**ITEM 6. SECTION 96(2) APPLICATION: 1 ALFRED STREET, 19 - 31 PITT STREET AND 31A PITT STREET SYDNEY****FILE NO: D/2015/1049/A****DEVELOPMENT APPLICATION NO: D/2015/1049/A****SUMMARY**

**Proposal Summary:** The subject Section 96(2) application seeks consent to modify the approved State Significant Development (SSD) Stage 1 building envelope for two mixed use towers at 1 Alfred Street, 19 – 31 Pitt Street and 31A Pitt Street, Sydney. The application seeks to vary the maximum height of Tower A to RL 200 (194 metres) from the approved RL 191 (185 metres). Minor variations are also sought to the number of storeys, floor-to-floor heights, indicative floor plate layout and distribution of gross floor area (GFA) across the site. No modifications to Tower B are proposed.

**Figure 9:** Proposed Tower A envelope subject of this Section 96(2) application (Source: Urbis)

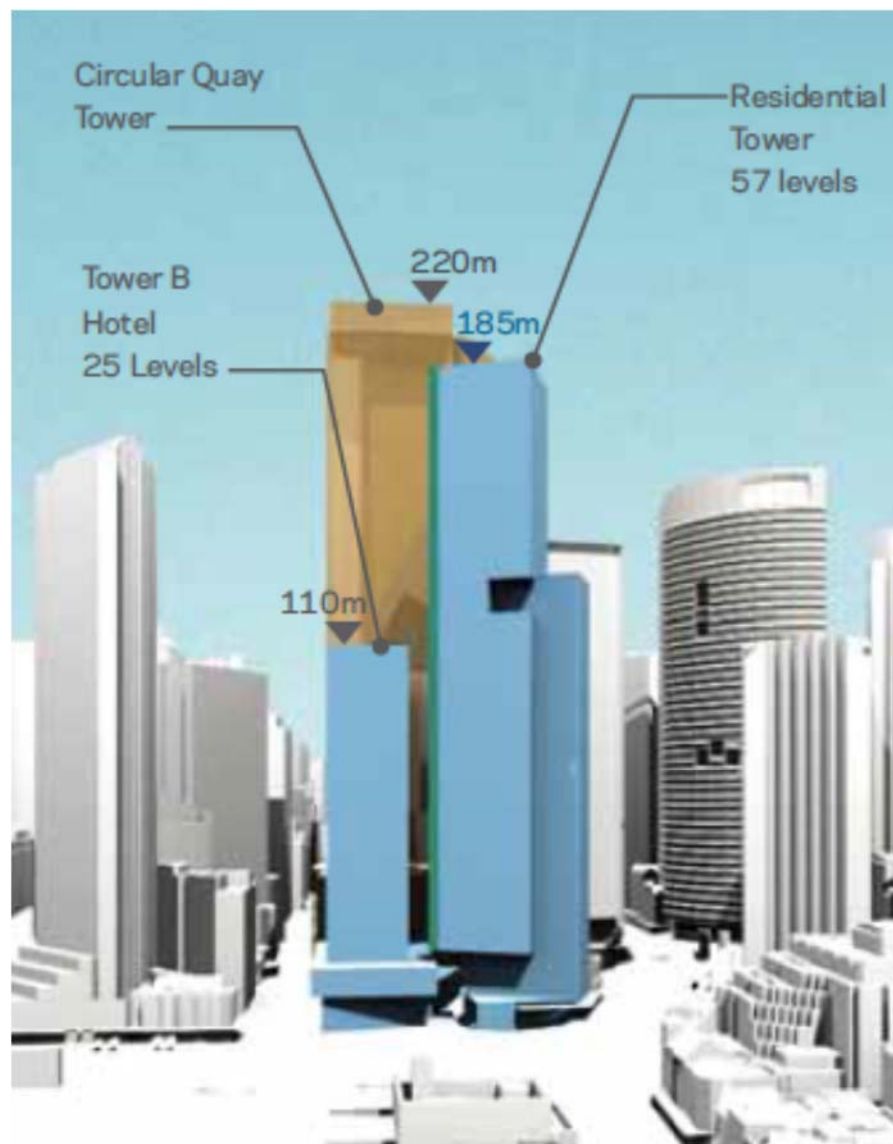
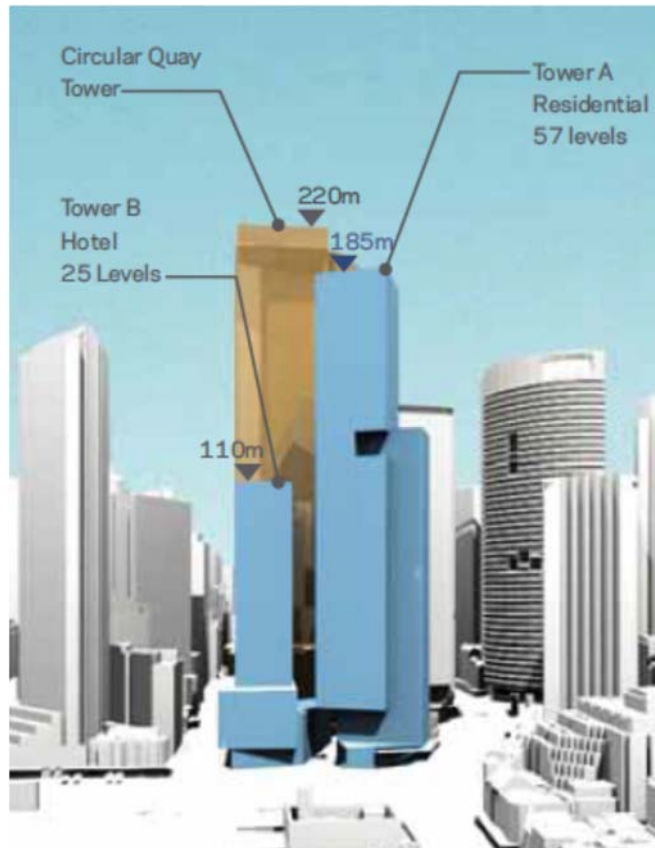
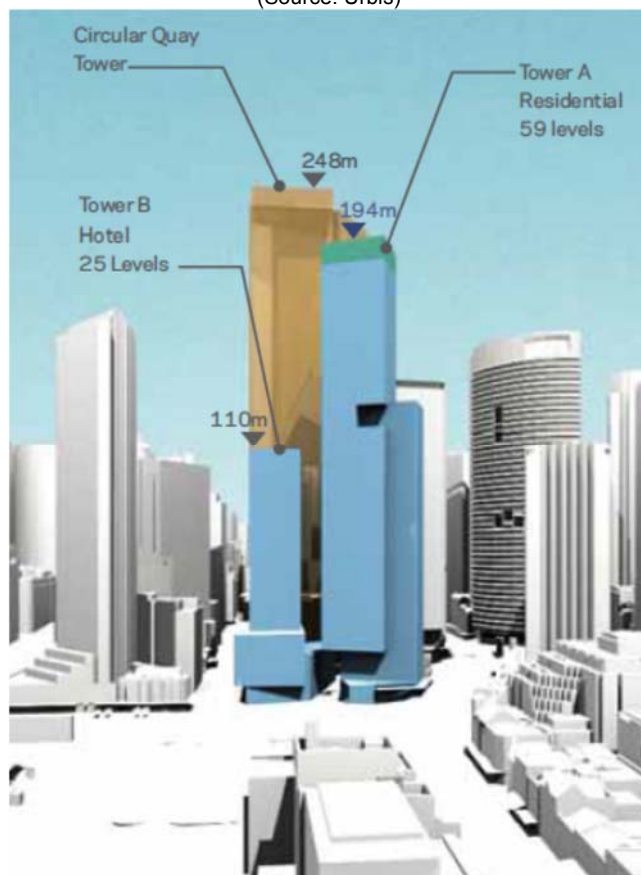
21. The approved building height of Tower A is RL 191 (185 metres). The subject Section 96(2) modification seeks to increase the approved building height by 9m to RL 200 (194 metres). No amendments to floor space ratio (FSR), floor plates, building separation or setbacks are proposed.
22. **Figure 6** below provides a comparison of the approved and proposed envelopes.

25. Notwithstanding the above, the proposed modifications make no change to the approved building footprint of Tower A, which represents 26.5% of the 1 Alfred Street site area.

26. In proposing additional height to Tower A, the Applicant intends to utilise residual GFA for the site resulting from deletion of a 900mm extension that was sought at the eastern side of Tower A in the original SSD Stage 1 consent. This GFA is proposed to be transferred to the top of Tower A and distributed across two additional levels. **Figure 7, 8 and 9** below demonstrate this proposed shift in GFA.

**Figure 10:** View of skyline looking south toward CBD (addition in green) (Source: Urbis)

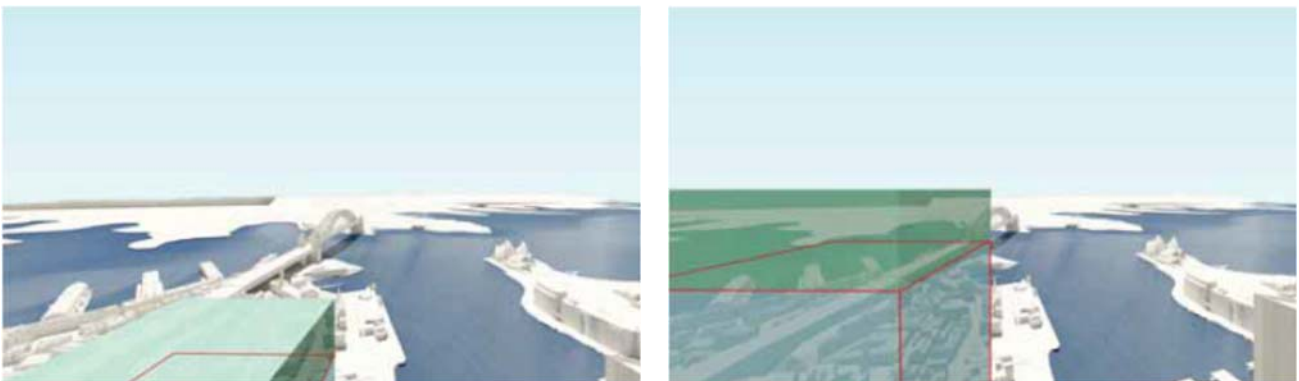
- (a) When viewed against the prominent base height at the Circular Quay waterfront, the proposed building envelope is appropriately sited within the skyline at a height commensurate or transitional to other visible towers including the existing and approved AMP tower, Four Seasons Hotel, Grosvenor Place, Barangaroo and various towers at the east of the city.

**Figure 13:** Alternative view of skyline from Circular Quay Tower at RL 220 (L) and RL 200(R)

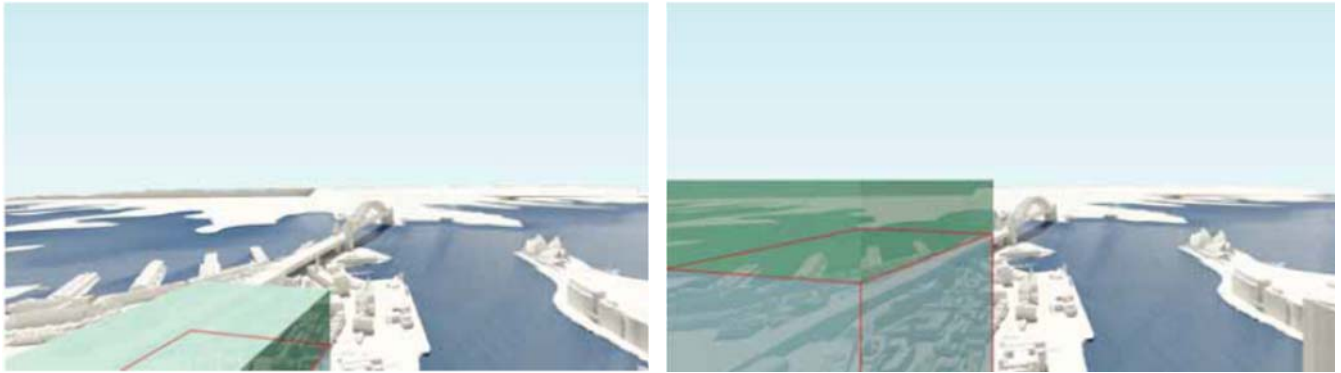
- (b) The proposed amendment to building height will have a negligible impact on public open spaces or key streets within proximity of the site. When viewed from these locations, the additional height of 9m will be imperceptible and not obscure important public domain views.
- (c) The increase in height will result in moderate view loss from the northwest aspect of Circular Quay Tower between RL 191 and RL 220. This represents two storeys within the indicative building envelope (yet to be approved). The extent of view loss is indicated in **Figure 12** and **13**. It includes part of the Harbour Bridge. The tower will, however, retain iconic views of the Opera House with visibility to the Harbour and sky view. In this regard, the proposal allows for an appropriate level of view sharing.

**Figure 14:** View of skyline from Grosvenor Tower at RL 160 (L) and RL 120 (R) (Source: Urbis)

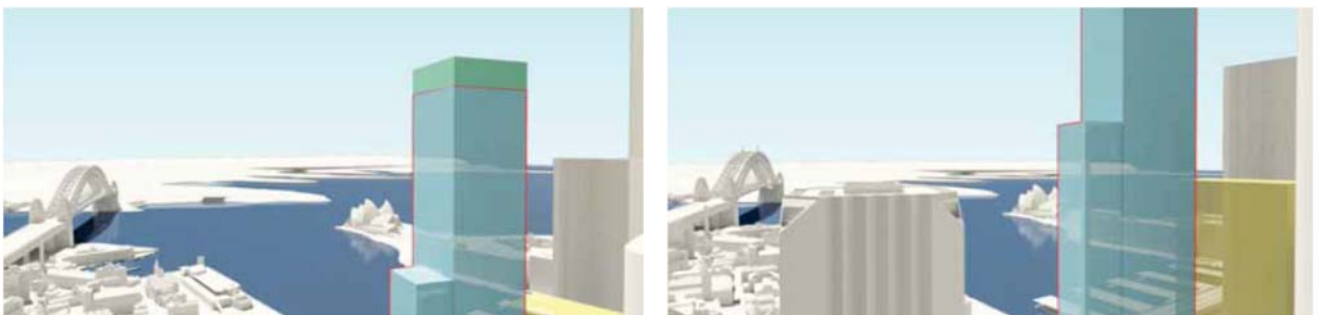
- (d) The approved height of Tower A at 185m exceeds the maximum height of 200 George, being 150m including plant. Accordingly, no further impact to the view corridor will occur as a result of the proposal.
- (e) The additional height will have no impact upon views from Grosvenor Tower or The Cove Apartments toward the northeast aspect. However, will cause minor loss of sky view. As illustrated in **Figure 14** and **15** over page, this loss is negligible and will be indiscernible to building occupants.

**Response** – As discussed within the submission, Grosvenor Place comprises 44 levels, with Level 44 located at RL 172 (RL 173.5 at standing eye level). The subject site as approved is at RL 191. Therefore, with the exception of sky view loss, the proposal at RL 200 is unlikely to have any further impacts upon Grosvenor Place at RL 173.5.
